Bewsher
Report.

10 January 2013
Ref: J1898L_2

TALLAWARRA LANDS PROJECT SUPPLEMENTARY FLOOD RISK ASSESSMENT REPORT

We write to provide a response to the matters raised by Evans & Peck (E&P) in their review of flood risk management issues associated with the Concept Plan submission for the above project.

Illustration A: Old Railway Bridge Survey (provided by BMT WBM from DCFS)

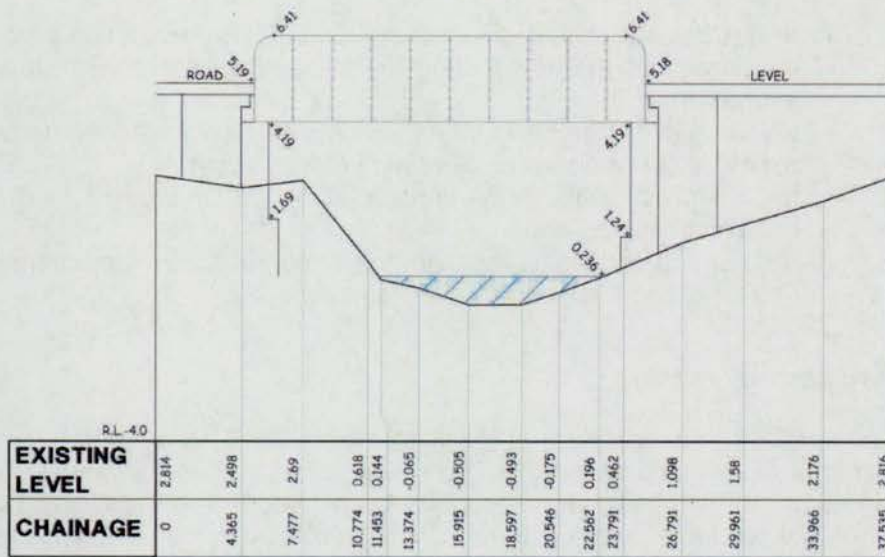
The considerable differences between the FRA and DCFS flood levels at the old railway bridge (i.e. Location '3') are apparent in **Table 1** and were raised by E&P in their email after an initial copy of **Table 1** was provided to them for review. (Unfortunately the initial table provided by us contained some typing errors which has hindered E&P's review and for which we apologise).

To assist with understanding the flood behaviour at the structure, a survey and photograph are reproduced in **Illustrations A** and **B** below.

The FRA has assumed the bridge (and its abutments) are in place but with no blockage. The 19m width between the abutments in the FRA model agrees closely with that in the DCFS model (see **Illustration A**).

The approach to the modelling of the old railway bridge in the DCFS is not clearly documented and has been clarified by telephone discussions with BMT WBM following our separate discussions with E&P. The allowance for blockage and possibly differences in the surveyed bed levels, have produced higher levels in the DCFS model. Further as can be seen from **Illustration A**, once water levels rise high enough to touch the underside of the bridge superstructure (i.e. 4.19mAHD) the passage of flood flows becomes significantly constricted and upstream water levels are likely to rise even further. This appears to be the principal reason for the significant differences between the DCFS and the FRA flood levels immediately upstream of the bridge.

The FRA has not made any separate allowance for increased flood levels resulting from construction of a future bridge. Whilst the design concept of the new bridge has not yet been determined, the removal of the current abutments will likely result in a significantly larger waterway area, which even after allowance for blockage (25%) would be unlikely to see the flood levels rise above the FRA estimates. In any event modelling will be required to determine the upstream flood levels so that other future components of the project, whose design will be dependent on these flood levels, can be designed. (Refer proposed additional commitment 'f' in **Attachment A**).

Figure 1:

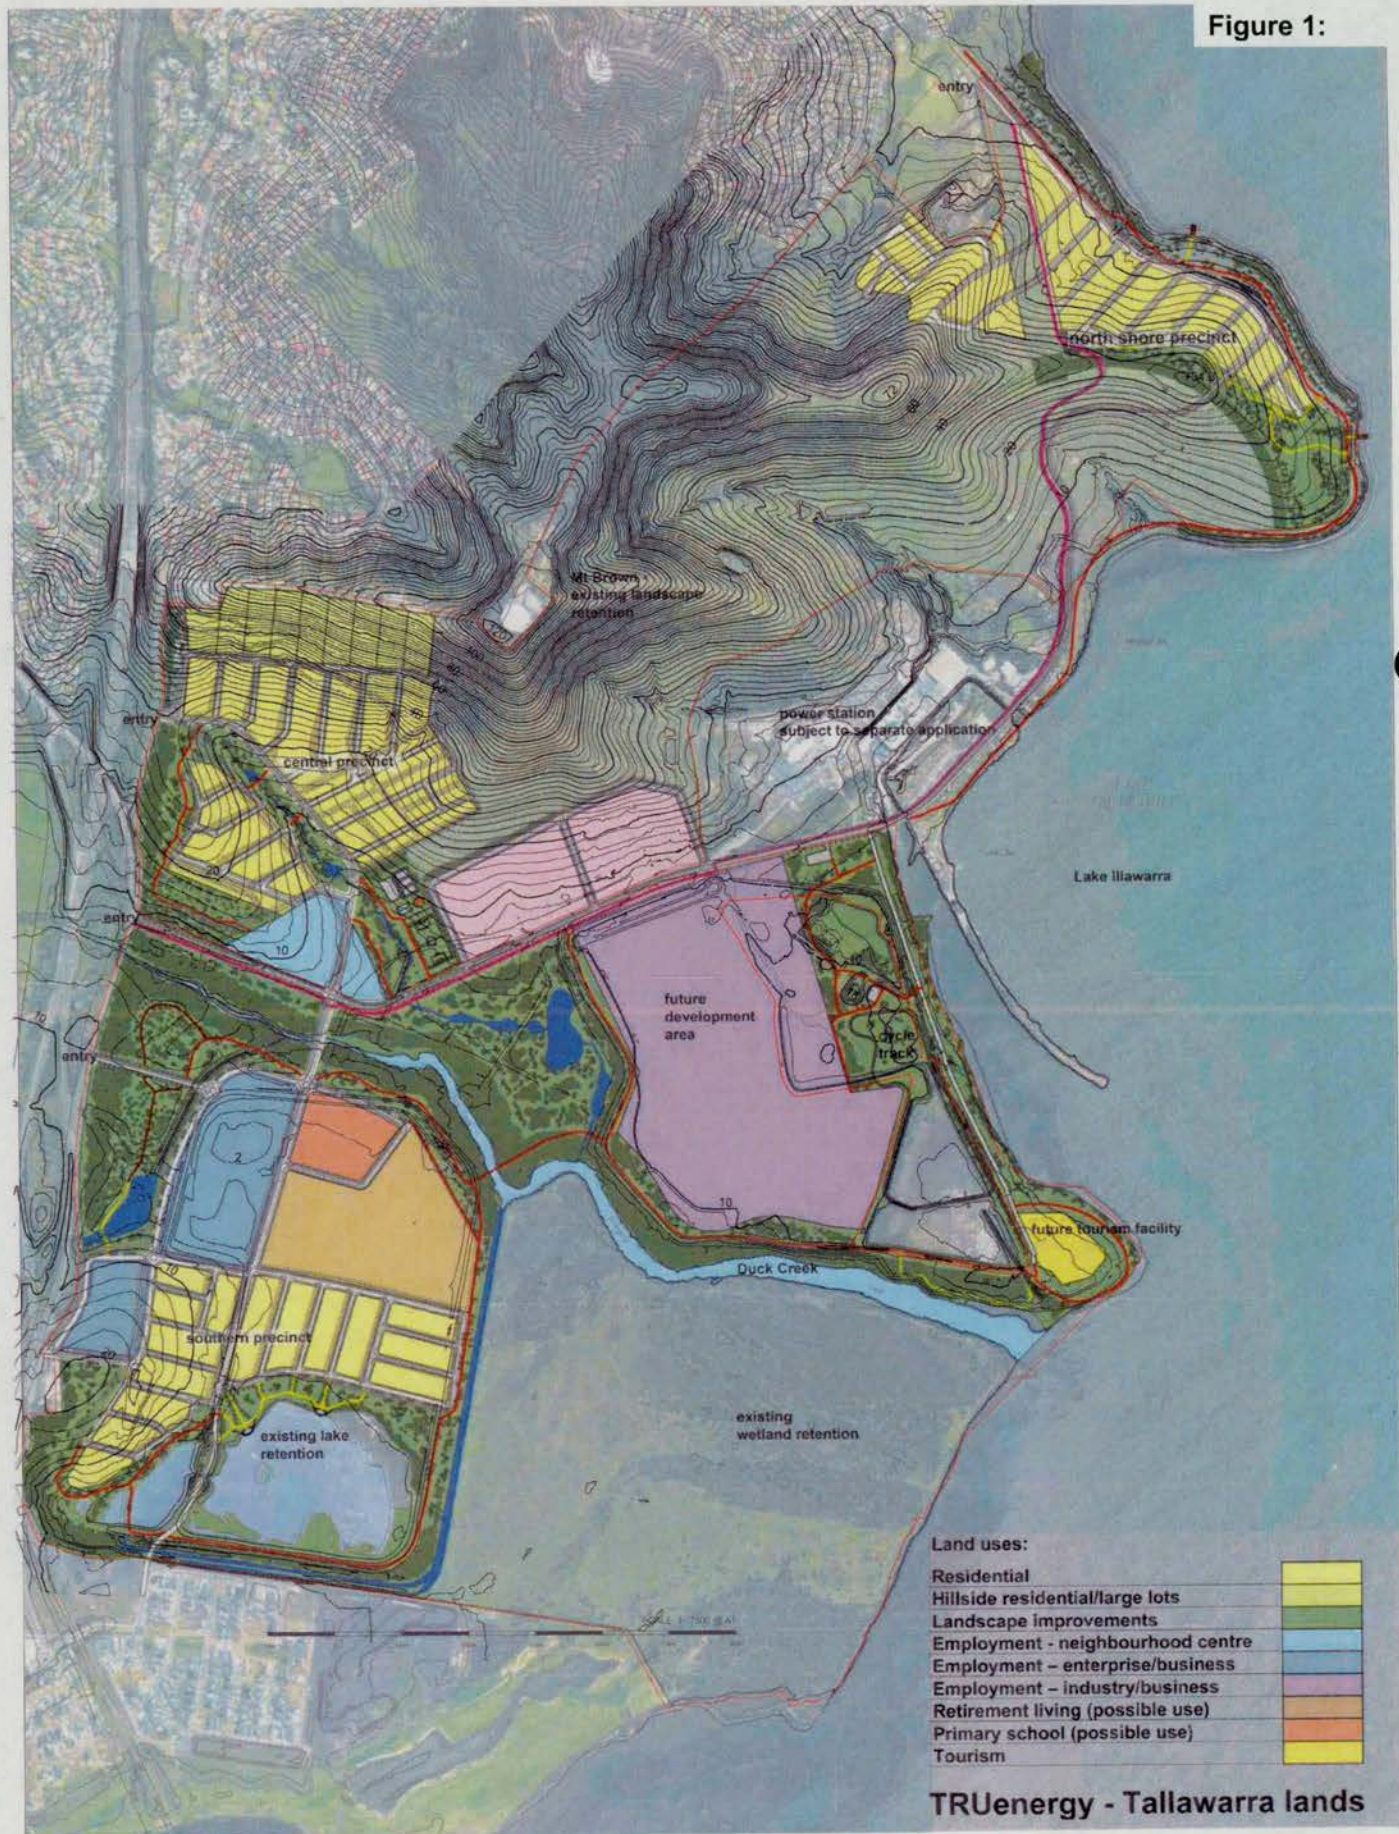
1. Provision of a detailed contour map of the existing site topography with the proposed development footprint overlaid. This has been prepared and is presented in **Figure 1**. The corresponding extent of fill within and adjacent to the Duck Creek 100 year ARI floodplain is shown against the 2010 FRA's floodplain map in **Figure 2**. It can be seen that there is only the one minor incursion into the 100 floodplain (on the western boundary of the Southern Precinct – see western 'red pocket' on **Figure 2**).

Figure 2:
Existing Conditions 100 Year ARI Flood Envelope
Floodplain Fill Areas and Evacuation Routes

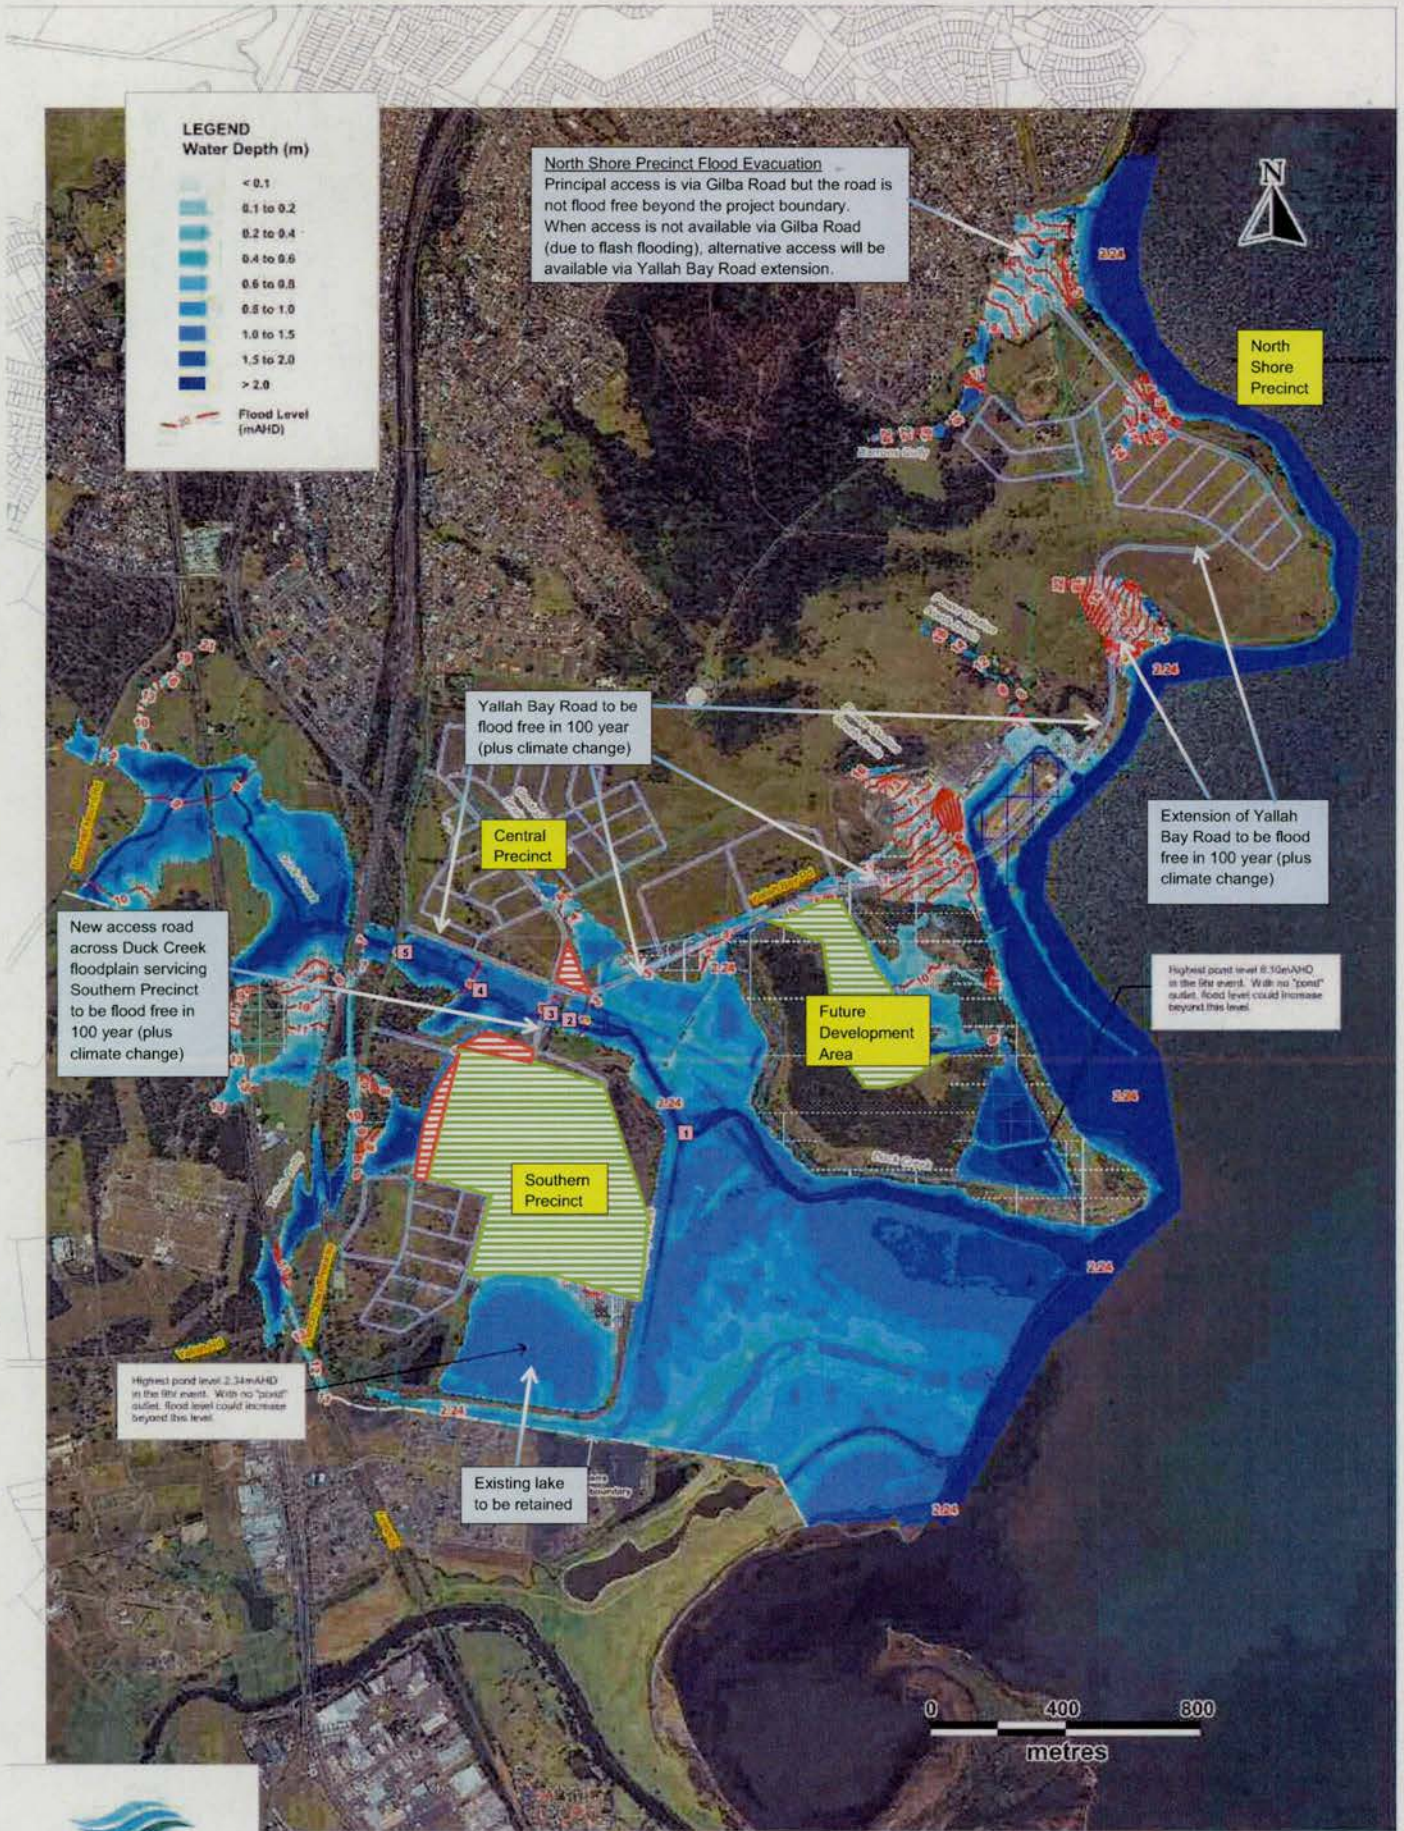
5. Mapping of Proposed Evacuation Routes. As requested, descriptions of each of the main evacuation routes and their access status have been included in **Figure 2**. It is important to note that all roads from each proposed house/property could be used as an evacuation route. All evacuation routes (with the single exception of Gilba Road which will provide daily access for the North Shore Precinct) will have levels which are no less than "the 100 year flood after allowing for year 2100 climate change impacts" (as listed in the 2012 *Updated Statement of Commitments* and further clarified in **Attachment A**). It is important to note that the low point in Gilba Road is located beyond the site's northern boundary and hence the road will remain at current levels. However in flood events which temporarily restrict access via Gilba Road, alternative access will be able to be achieved via Yallah Bay Road.

8. Clarification of the extent of filling into the 100 year ARI floodplain. The extent of encroachment of fill into or adjacent to the 100 year ARI floodplain is shown in **Figure 2**. The 'red pockets' show where fill is proposed in floodplain areas whereas as the 'green pockets' show where fill is proposed in areas that are already bunded. (These green areas, whilst technically in the floodplain, are already isolated by bunding and consequently their filling has no impact beyond the bunded area).

Of the three 'red pockets' shown in **Figure 2**, it can be seen that the only pocket of any significance is located on the western side of the Southern Precinct (i.e. the lower left red pocket). The volume of flood storage displaced is slightly less than 1000m³ and this occurs immediately upstream of an existing dam on the Yallah Gully Tributary (which already blocks tributary flows). Because this encroachment is located on a tributary, there will be no impacts on Duck Creek flows and in any case, the upstream impacts on the tributary itself will be contained within the project area.

Moving further north, the middle red pocket is not in an area currently inundated by the 100 year flood but may possibly be so if climate change impacts are considered. The upper red pocket is also located on a tributary of Duck Creek rather than the Creek itself. The volume of displaced storage is less than 100m³ and its impacts will not extend off-site. Nevertheless both the middle and upper red pockets have been shown as they may be within the Duck Creek floodplain in larger events (including for the effects of climate change). Given that the encroachment volume represents less than 0.005% of 100 year flood volume on Creek, the potential impact even in larger events, will be of no consequence.

It is noted that all filling (or other project works within the floodplain) will be designed consistent with proposed additional commitment 'd' which commits the Proponent to ensuring there will be no off-site flood impacts. In some cases this may necessitate provision of compensatory works or amendment of fill proposals (or other project works) to achieve this outcome.
